**PAUL HALAJIAN
ARCHITECTS**

ADDENDUM

PROJECT: **Clovis Landmark Square
Senior Activity Center and Transit Center**

ADDENDUM#: **03**

SHEET NUMBER: AD3 S509

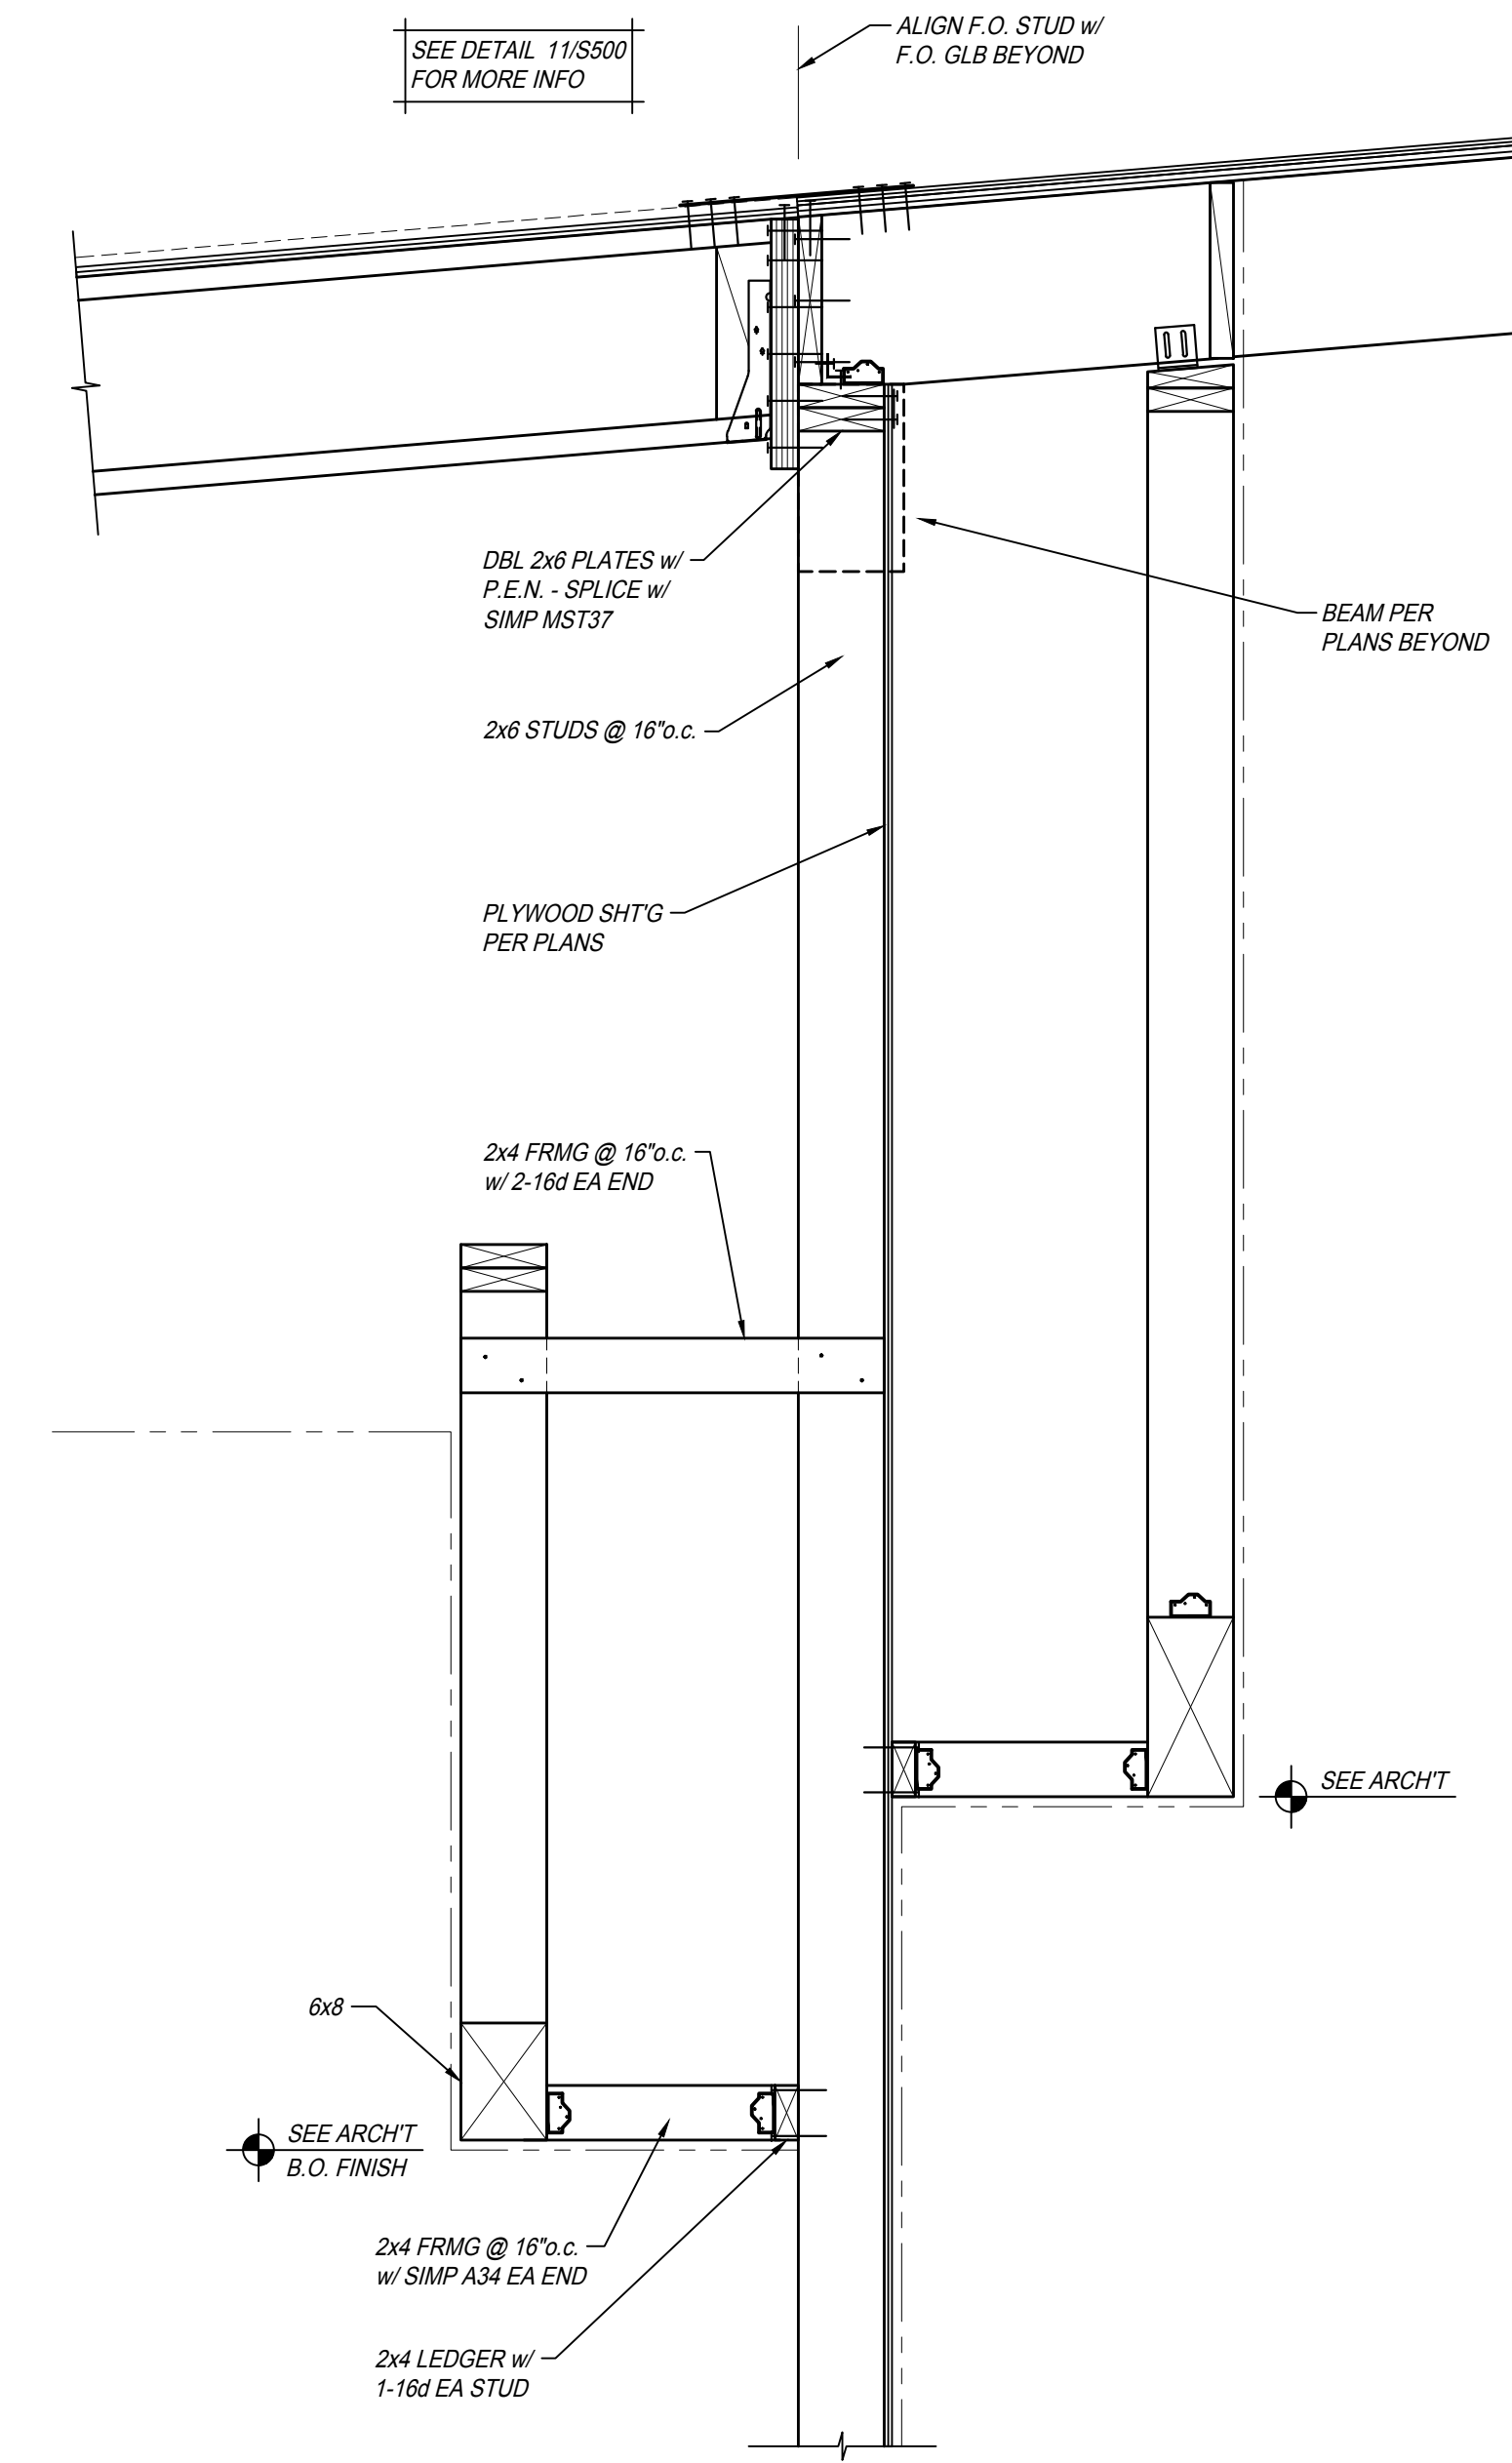
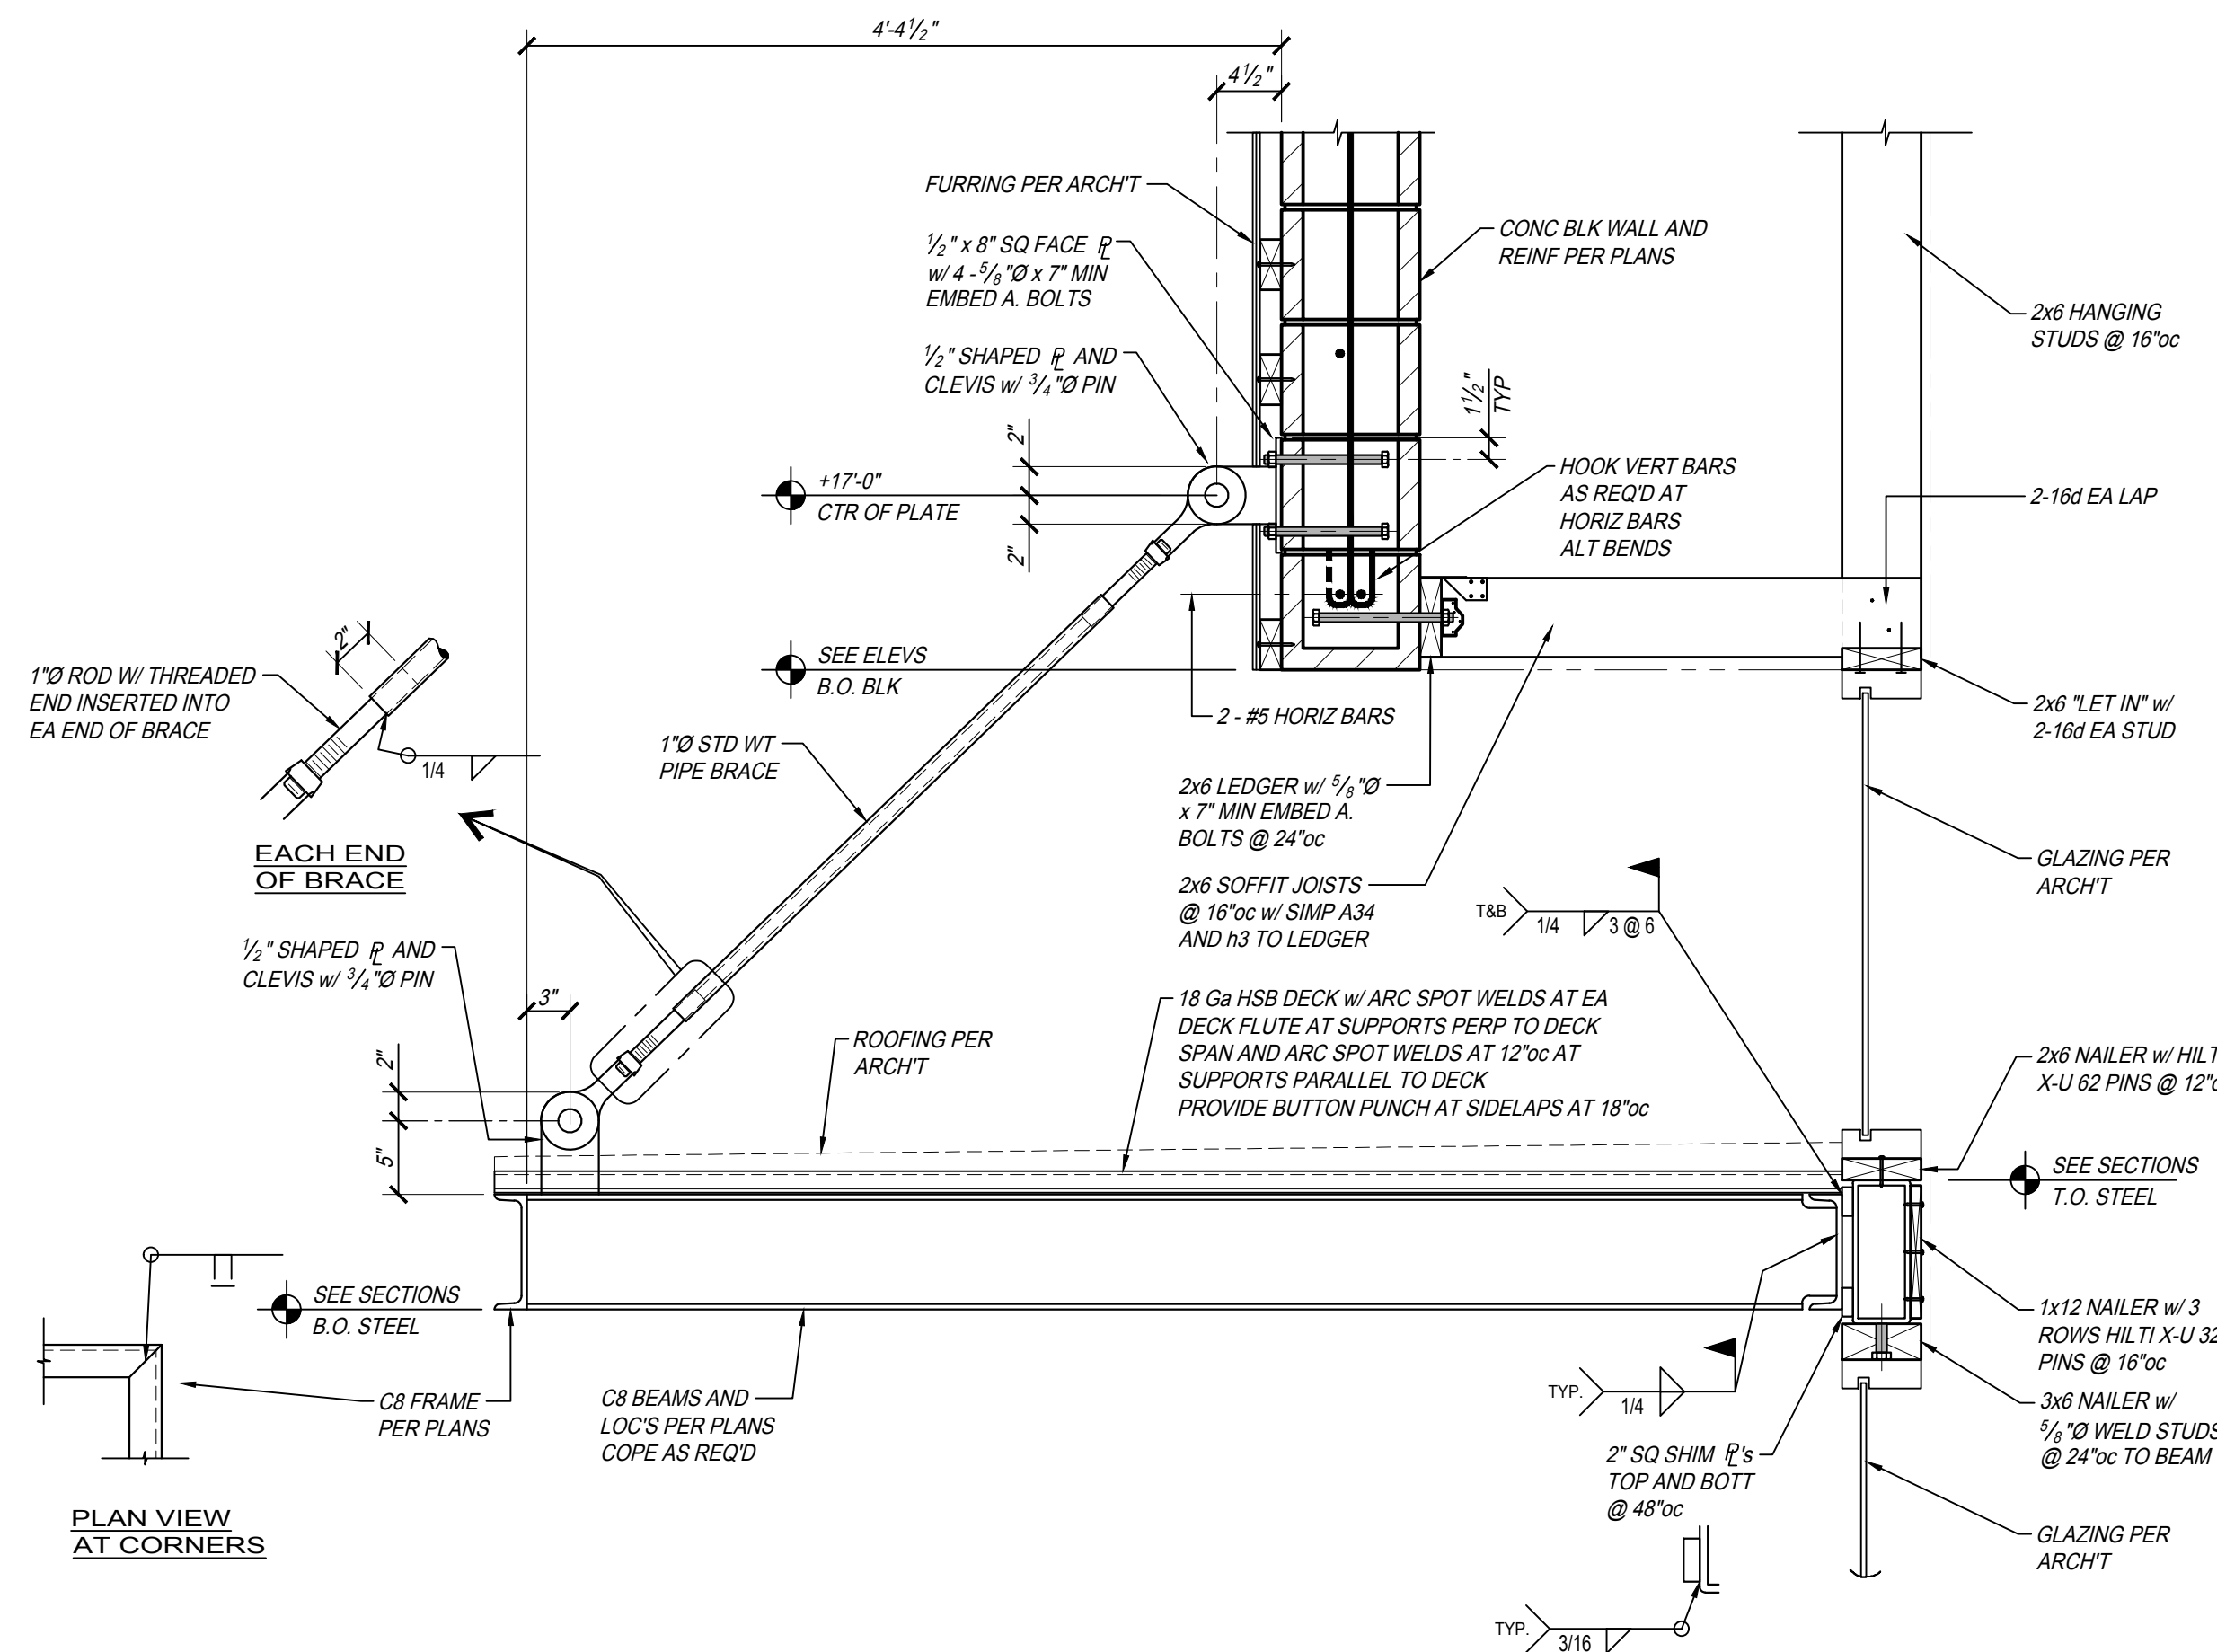
- a. Omit sheet **AD1-S509, Roof Framing Details** and replace with **AD3-S509, Roof Framing Details** attached. The following changes have been made:
 - i. See detail 8/S509 – Revised Plan View detail so it is fully shown.
 - ii. See detail 9/S509 – Revised spacing of All-Thread rods to beams.
 - iii. See detail 10/S509 – Revised spacing of All-Thread rods to beams.
